STATE OF NORTH CAROLINA
DEPARTMENT OF TRANSPORTATION

Subject: Revised Application for Modification to Neuse Riparian Buffer Certification:
Widening of Interstate 85 from west of US 15-501 to west of Broad Street,
Durham County, Division 5; TIP No. I-0306C; State Project No. 8.1414801;
Federal Aid Project No. I-85-4(49)174. USACE Action ID No. 20220949;
NCDENR-DWQ Water Quality Certification Project No. 021677.

Permit Drawing 7 of 21/Site 1

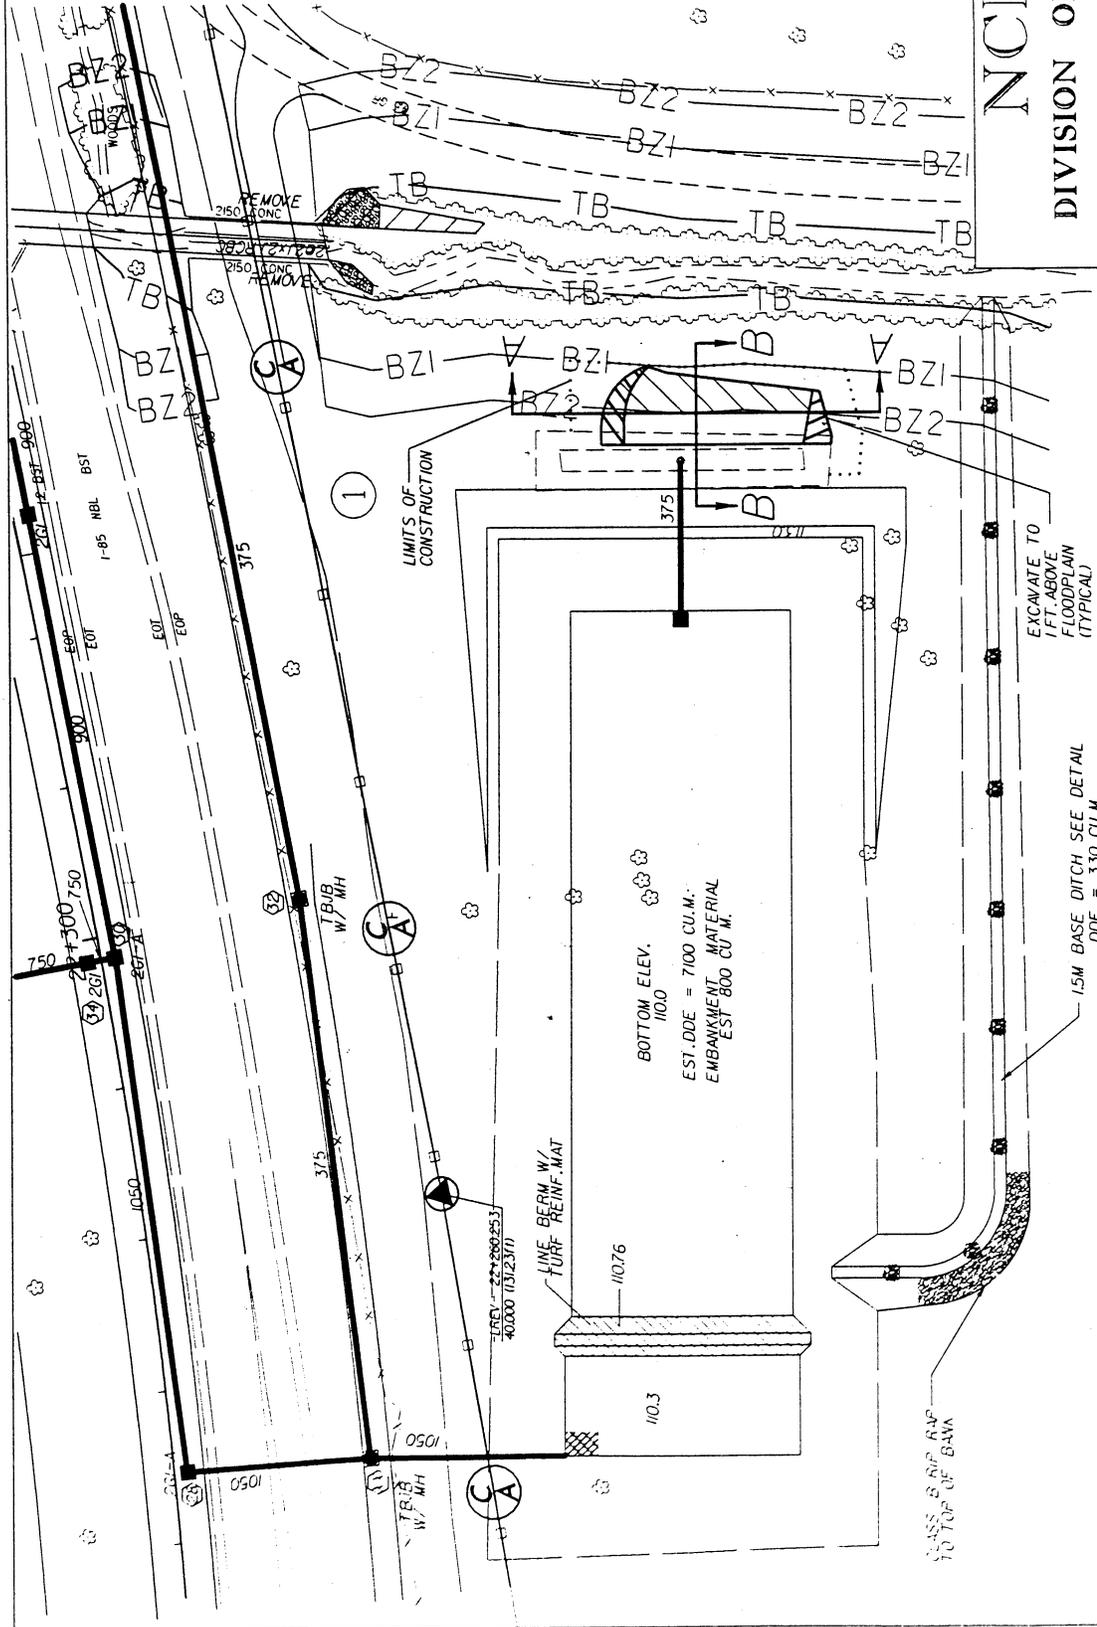
This modification is for changes to buffer impacts through the change in a level spreader design. The revised design does not compromise NCDOT's compliance with the existing permit conditions. The revision has been evaluated for compliance with the avoidance/minimization criteria and are in compliance with all previous issues, including the following:

The riparian buffers in this area have recently been disturbed by the Ellerbe Creek stream restoration project conducted by the EEP (DWQ Project No. 030368). The floodplain was excavated by this EEP project causing a redesign of the level spreader. It has been redesigned so that water will adequately flow through the natural stream design floodplain buffer at nonerosive velocities. The redesign will involve excavating and grubbing within the Buffer Zone 2.

Impacts in previous permits by NCDOT at this specific site did not require riparian buffer mitigation because impacts were below 150 ft; therefore, impacts were allowable with no mitigation required. EEP excavated through the entire riparian buffer at this site and then revegetated with floodplain species. The project was finished in May 2004. NCDOT is not requesting mitigation for impacts at this site because we feel that the redesign is necessary for the level spreader to function properly, but most importantly, because the riparian buffers in this area have already been recently permitted as an impact and disturbed by the EEP project. The NCDOT and EEP apparently share a construction easement at the permit site although NCDOT acquired their easement first.

The level spreader construction should only take a couple days and will be graded and seeded with native species after construction. There are no mature trees or shrubs within this area of the buffer and NCDOT has agreed to replant any trees previously planted by the EEP that are harmed during the construction. See the impact summary sheet for impacts from the previous permits and to the redesign of the level spreader.

EXCAVATE TO 1 FT. ABOVE FLOODPLAIN (TYPICAL)

1.5M BASE DITCH SEE DETAIL
DDE = 350 CU.M.
EST. 1720 MTONS CLASS 1B RIP RAP
EST. 3450 SQ.M.F.F.
